LUAS Cork

Public Consultation – Response

LUAS Cork – Emerging Preferred Route (EPR)

Fig 1 Possible Noth Quays Route

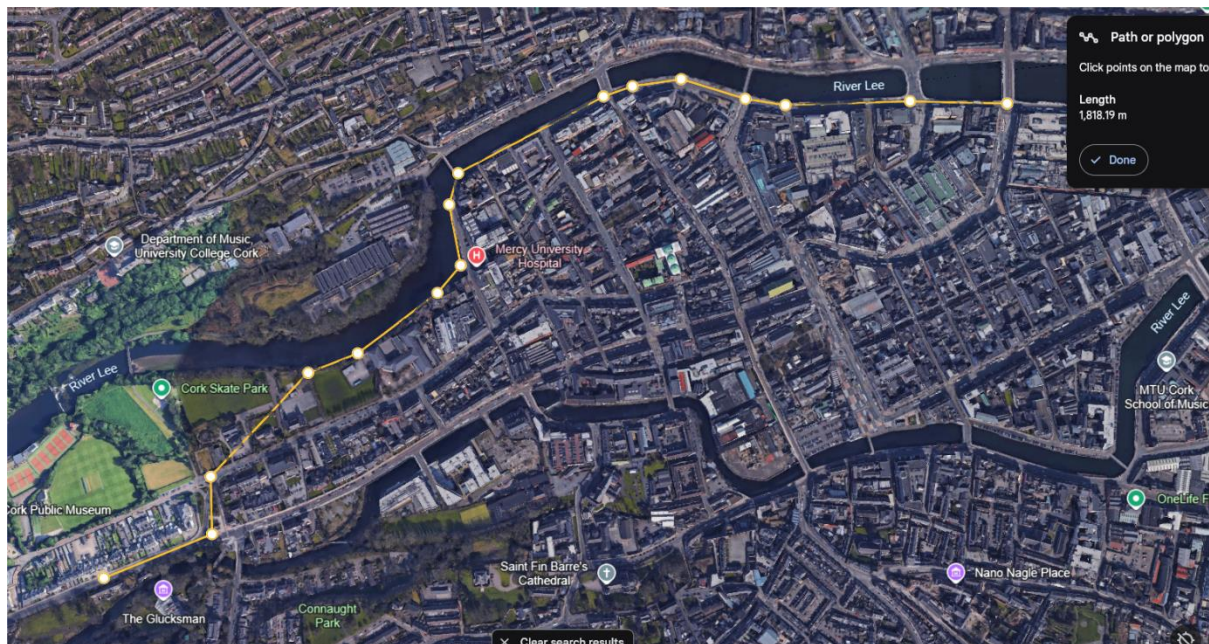
An **alternative routing Via the North Quays**. Advantages would be:

- A PT network that is more resilient to disruptions, as bus and Light rail would not share the same routing.
- Less on street running subject to delay from road traffic.
- The regeneration of the North Quays which is at present dominated by road traffic.
- Better service of underserved high density and demand areas on the inner Northside such as Shandon St area.
- The Cork Bus Station would be in closer distance to a LUAS stop, which is paramount to an integrated PT network in the city

- Washington and McCurtain Streets could be avoided. Both streets are approximately 18 m wide, this is very marginally narrower than Abbey Street in Dublin which presently carries a LUAS line. Using Abbey Street as a guide, this would require 7 m for the Light Rail line, a 3.25/3.5m wide traffic lane to allow deliveries and access, 3.5 m wide loading Bay, leaving only a narrow 2m wide footpath on either side. Unlike Abbey Street both Washington Street and McCurtain Street also carry bus routes, Using Abbey streets in Dublin as a guide it is very difficult to see how any bus lane or bus stop could be incorporated while allowing the unimpeded passage of a light rail line. See further discussion below. It may be possible to reroute busses away from McCurtain Street it is extremely hard to see how this could be done for Washington Street. While Abbey St is also a prime retail street, Washington and McCurtain Streets are also the prime hospitality and public realm space within the city in a way Abbey St is not in Dublin and as such the loss of public realm space on these streets would represent a significant blow to the city.

Fig 3 Land Bank between MTU and Clash Rd.

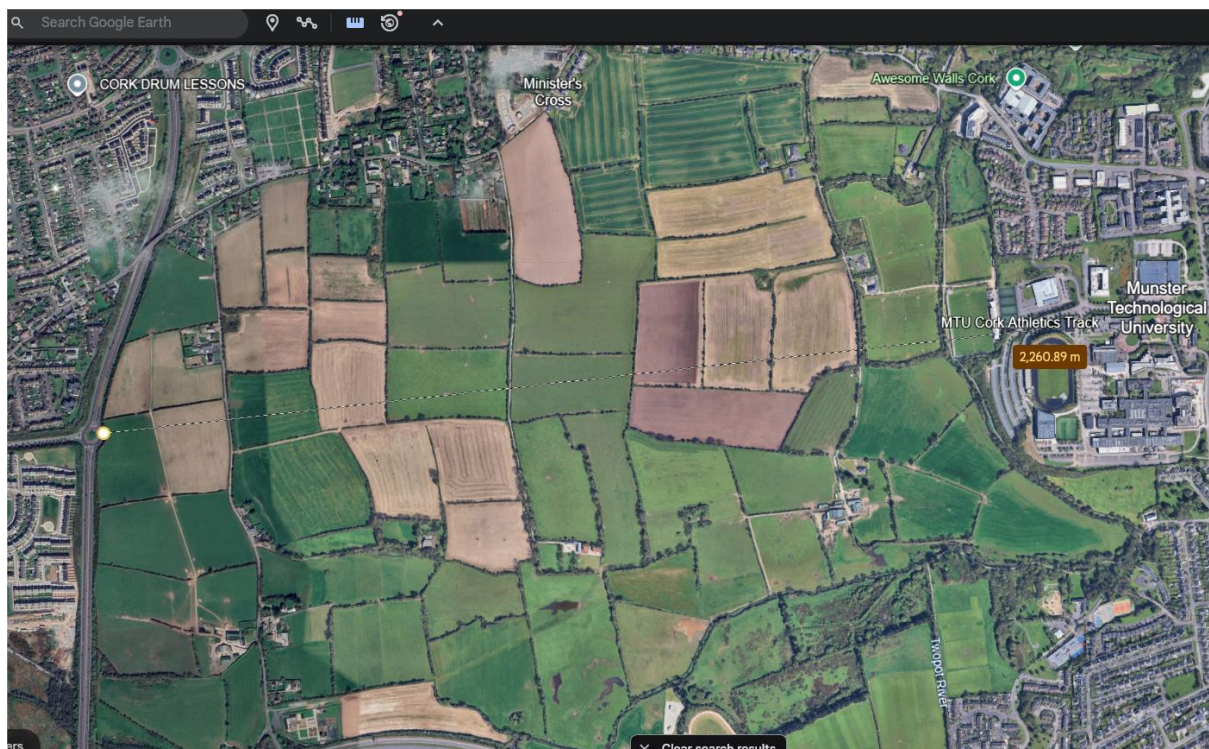
This is the rationale behind routing Light Rail through the proposed docklands development area. The approximately 2.25 km distance between MTU and the Clash Road offers an even greater opportunity for transit-oriented development and should include at least 3 proposed stations around which high density development can take place oriented around the stops. If the line is to deviate to the south serve the science park or in order to enter Ballincollig further West, see below, this would offer an opportunity for an even greater number of proposed station sites around which transit orientation high density development could take place. The opportunities for more compact and sustainable development which this offers should be seriously considered.

In order to facilitate this the proposed route should be taken into public ownership at the earliest opportunity In the greenway and subsequent busway (limited access street) built-in order to allow the beginning of development around proposed stations in advance of the building of the light rail to avoid the situation where development cannot begin to take place until after the light rail project has been complete.

It is of vital importance that land in close proximity to stations should be used for the highest football activities. Due to the unique potential of this area we think that it is inappropriate for the park and ride or depot to be located in this area and it should more properly be located on the Western edge of Ballincollig at a more appropriate terminus, see below.
